2012 EVALUATION OF RECREATIONAL PARKS/PLAYGROUNDS

FOR
SAFETY INSPECTION – ADA COMPLIANCE

Borough of Tenafly
100 Riveredge Road
Tenafly, NJ 07670

MASER CONSULTING P.A.
331 Newman Springs Road, Suite 203
Red Bank, NJ 07701

FROGGY PLAYGROUND

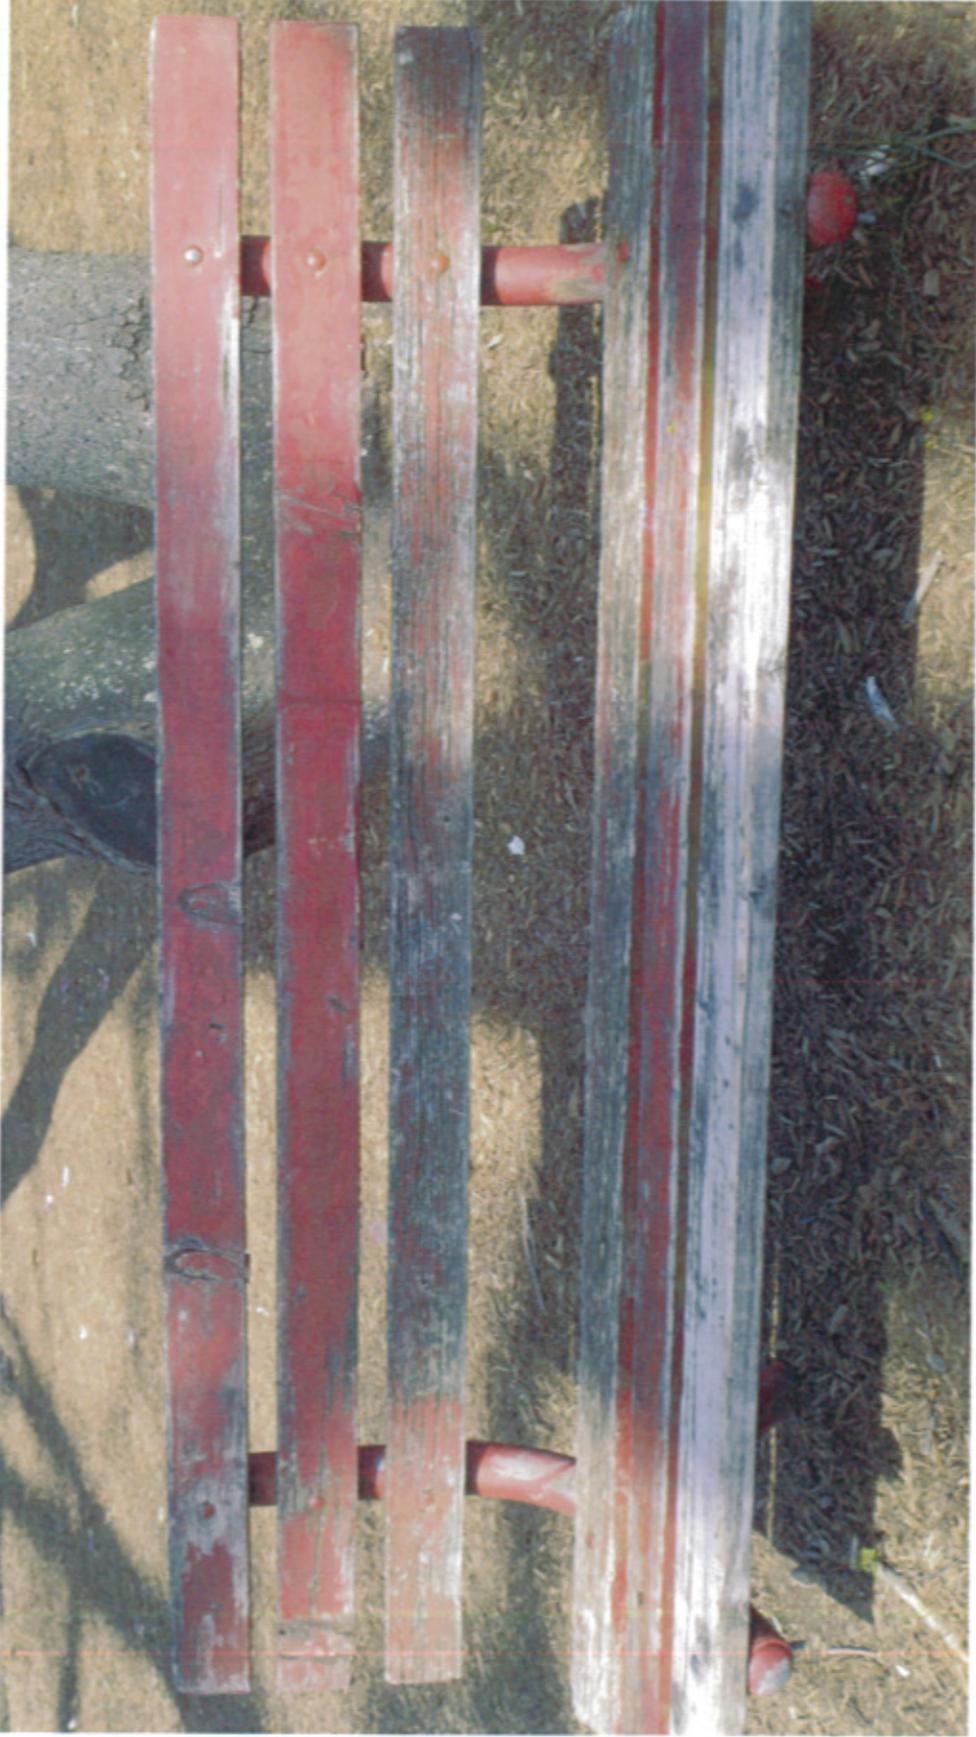
OLD SITE AMENITIES SHOULD BE REMOVED

TREES LEANING BEYOND AN ACCEPTABLE STANDARD, SHOULD BE REMOVED TO AVOID A HAZARDOUS CONDITION

FROGGY PLAYGROUND

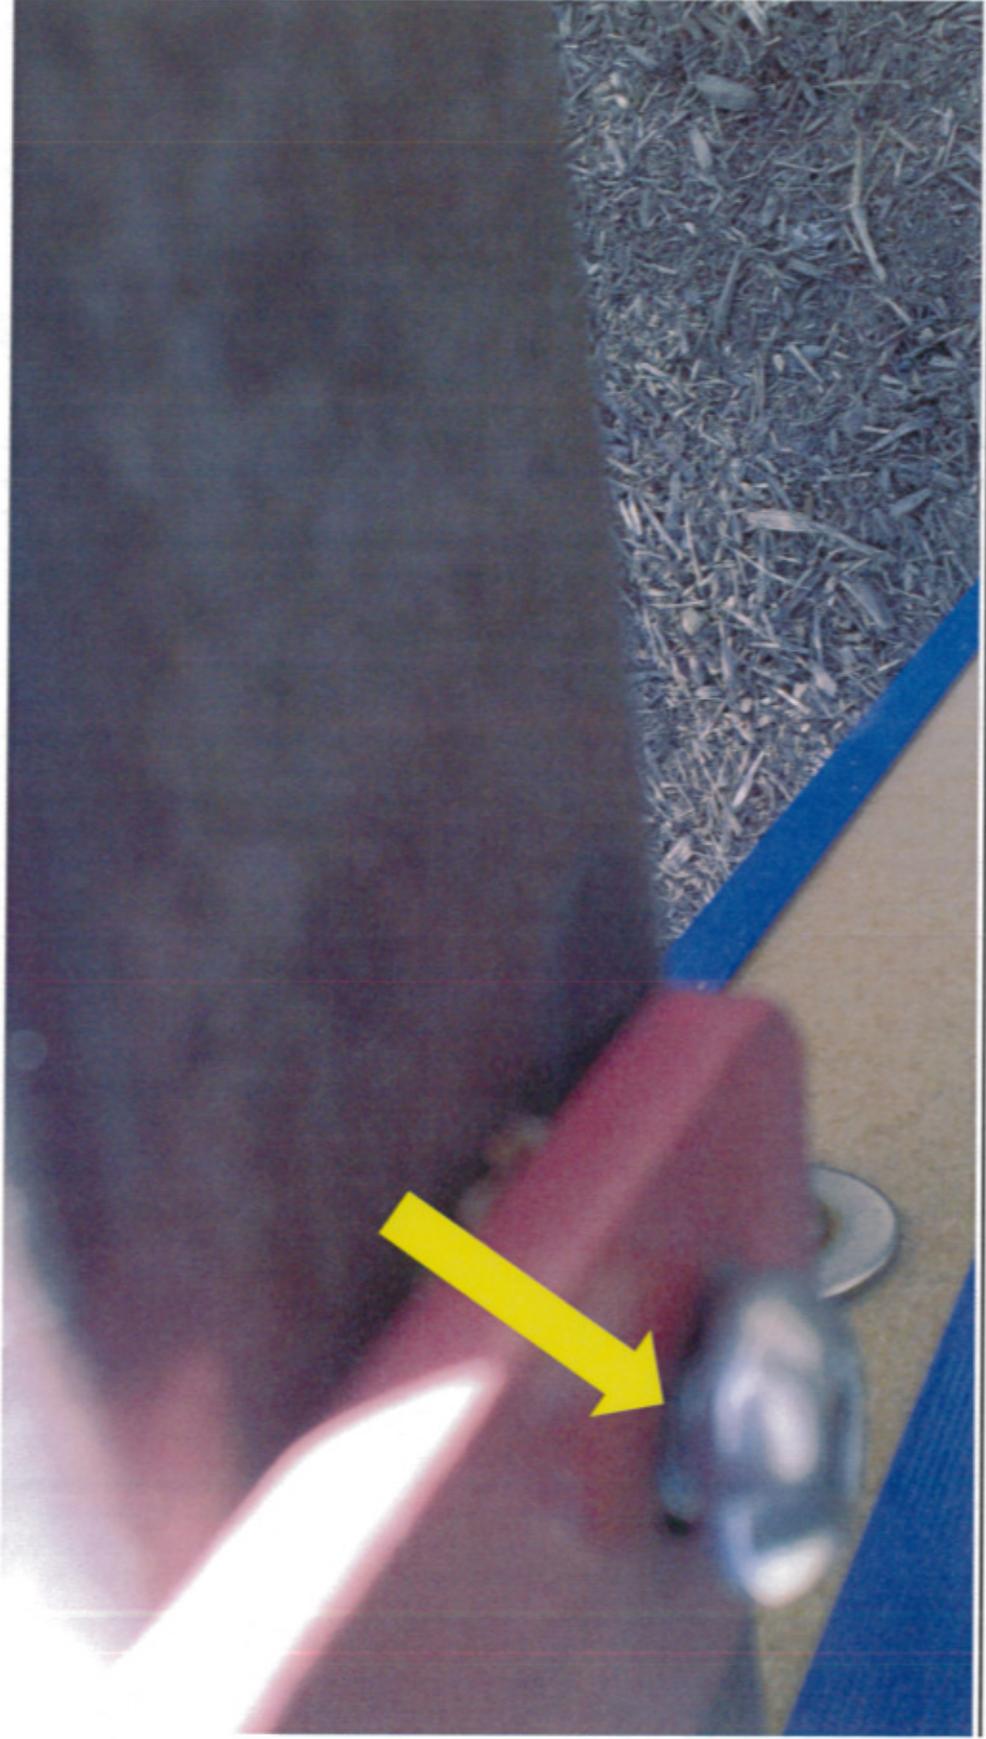
LOOSE BOLT AND STRIPPED BOLTS THROUGHOUT PARK

FROGGY PLAYGROUND

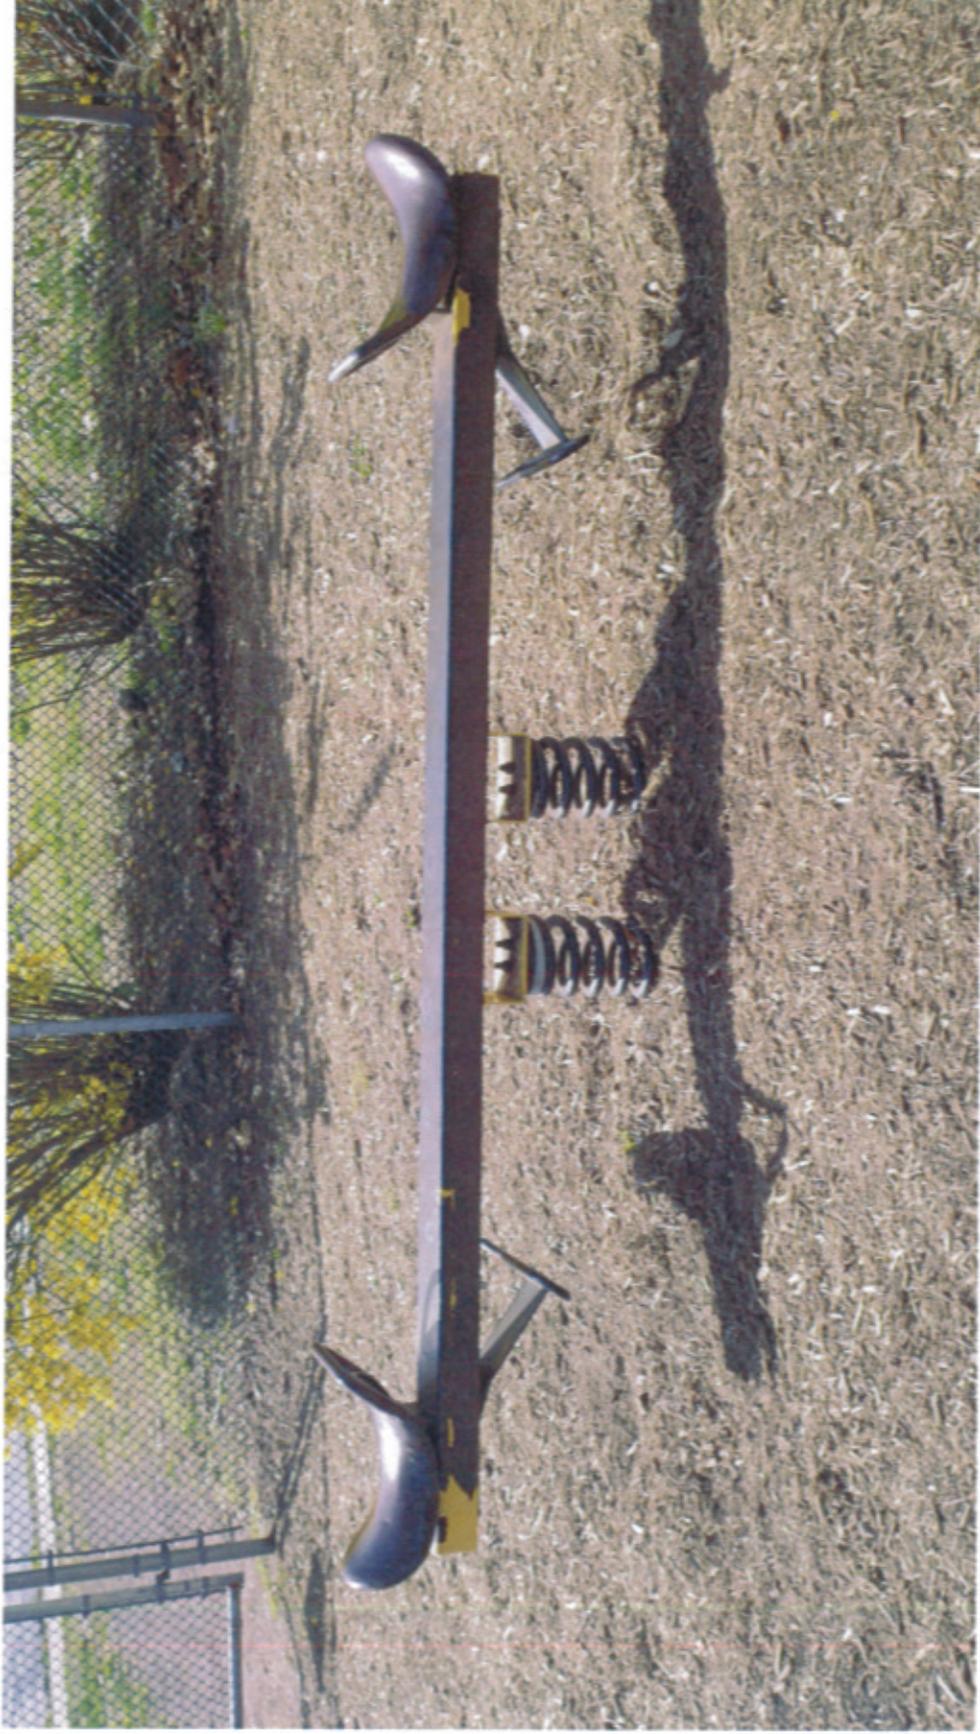
DAMAGED SPIRAL CLIMBER WITH LOOSE BOLT ATTACHMENT

FROGGY PLAYGROUND

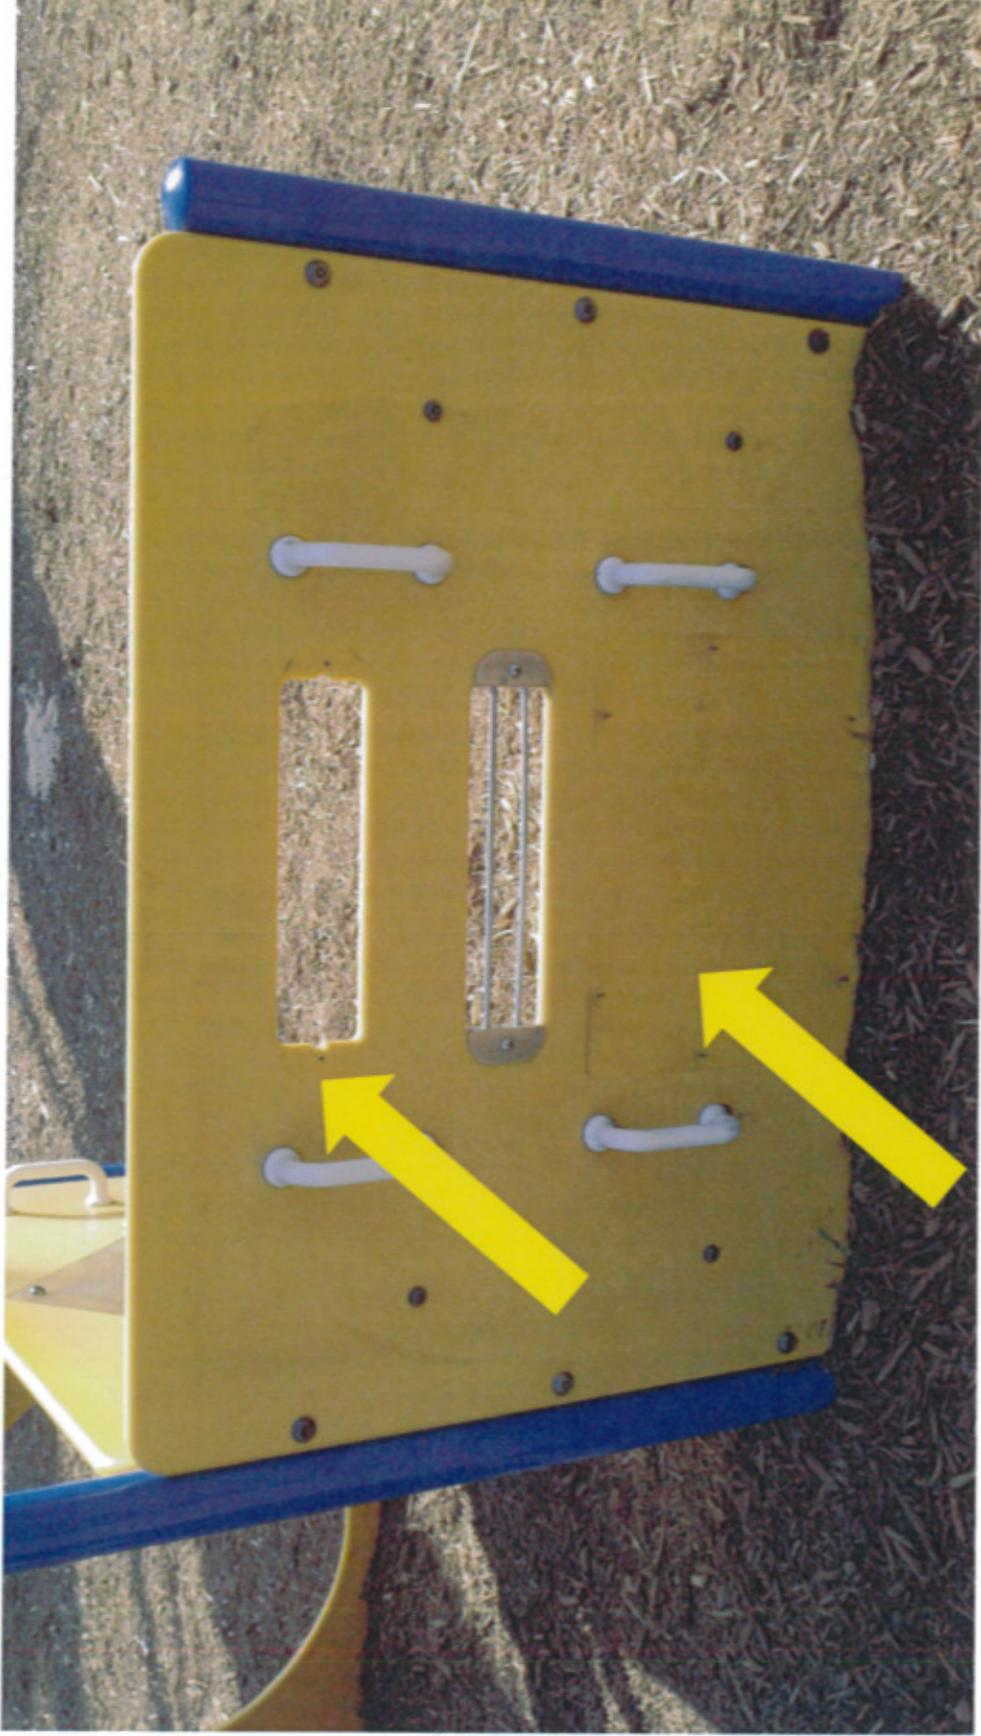
MISSING COMPONENTS ON PLAY STRUCTURE

ROOSEVELT COMMON PLAYGROUND

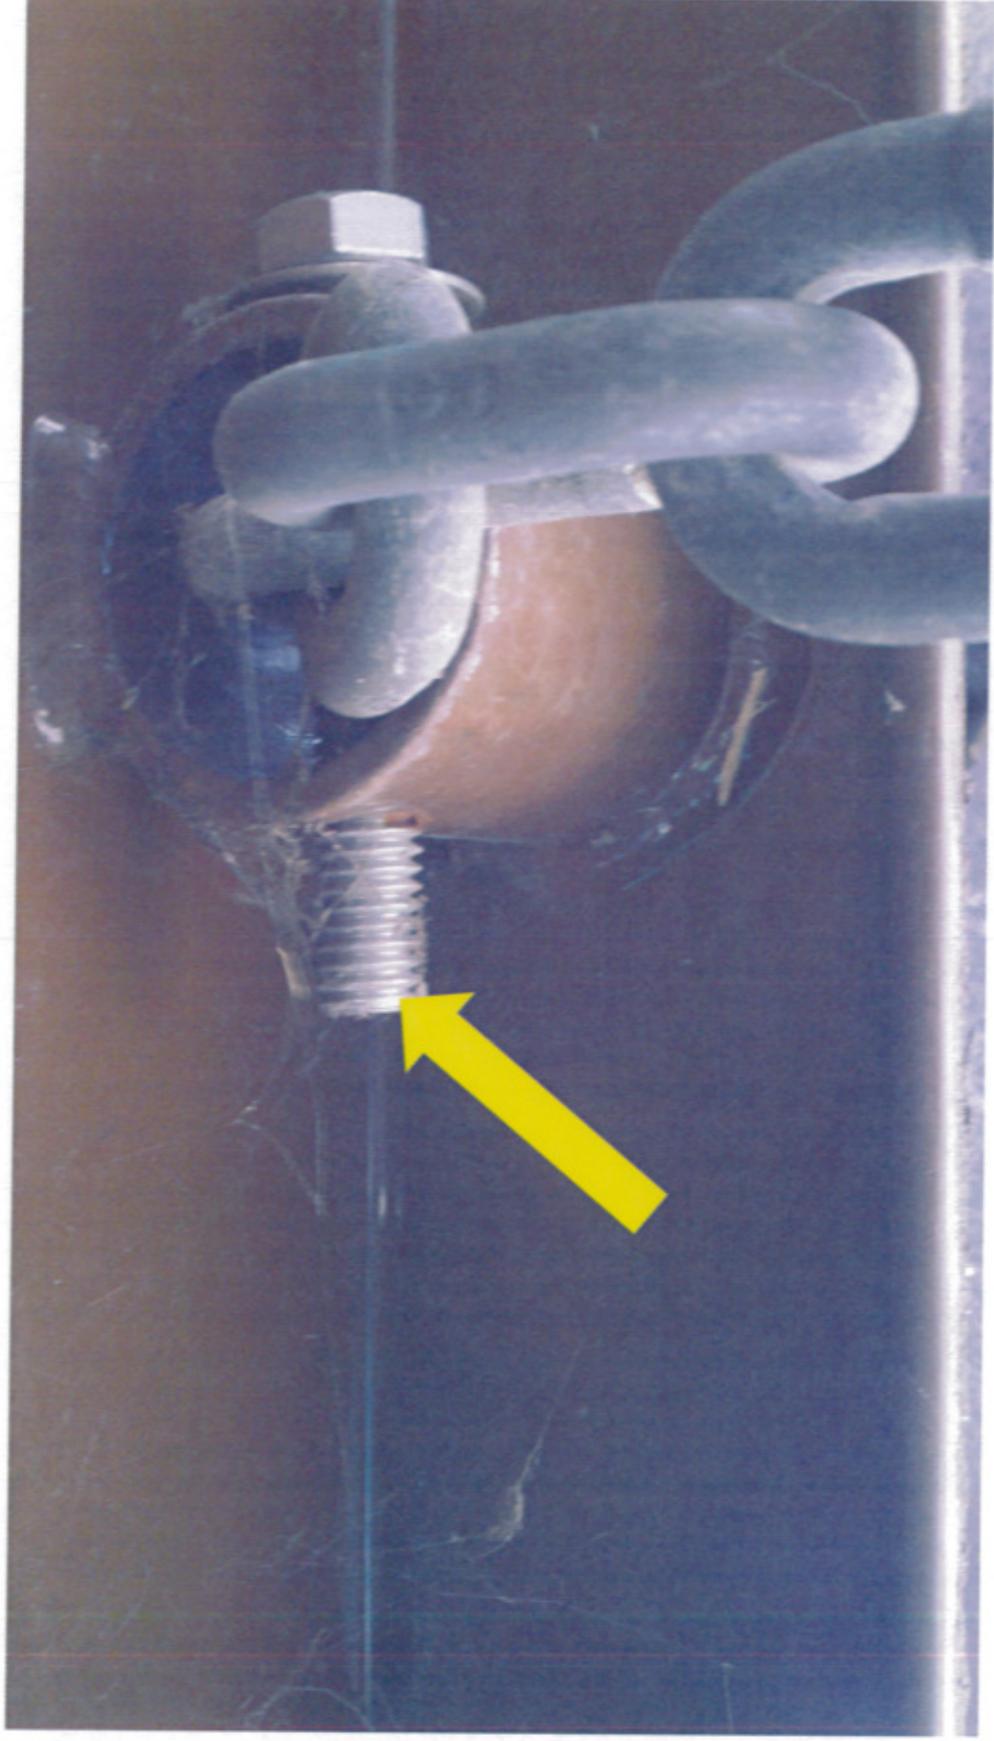
AREA DOES NOT PROVIDE AN UNINTERRUPTED ADA COMPLIANT PATH WAY

ROOSEVELT COMMON PLAYGROUND

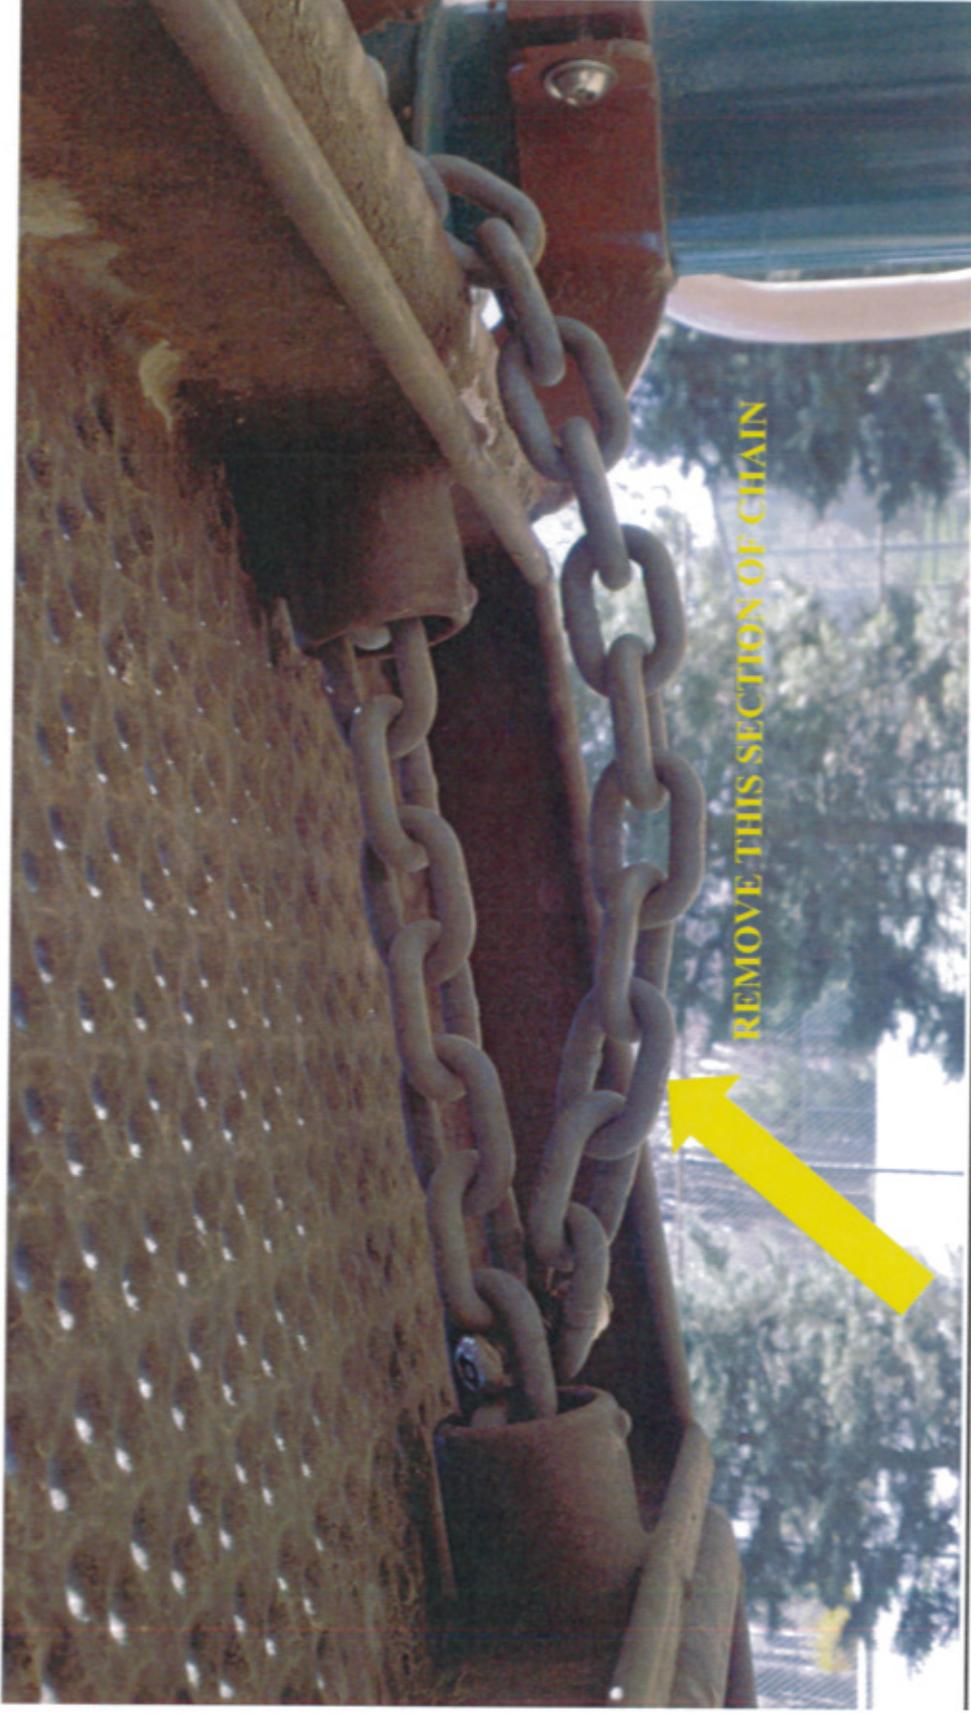
**DO NOT PERFORM REPAIRS TO CLADDER BRIDGES WHICH DO NOT FOLLOW
MANUFACTURER GUIDELINES**
